Bulletin 0-3-3

Errors and omissions in 2009 Ontario Electrical Safety Code

Issued April 2010
Supersedes Bulletin 0-3-2

Appendix B note Rule 68-054

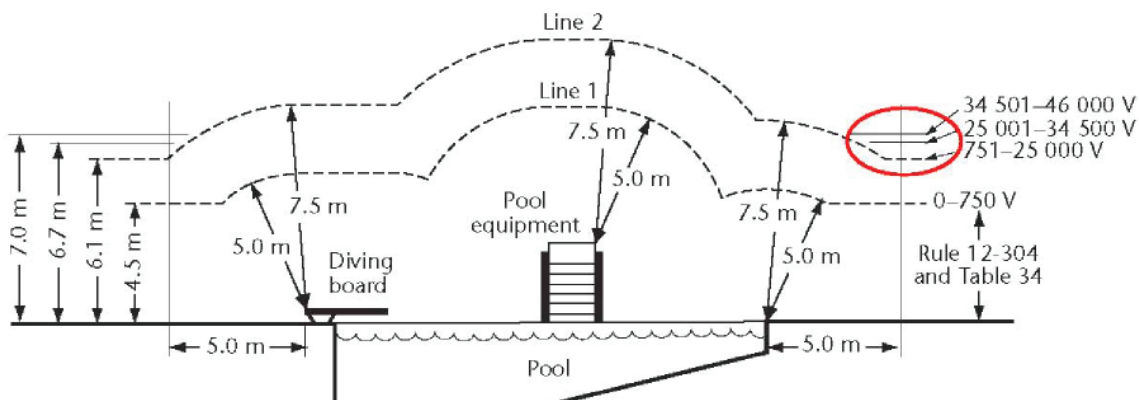
The figure should be replaced with the following (the correction is identified in the circle):
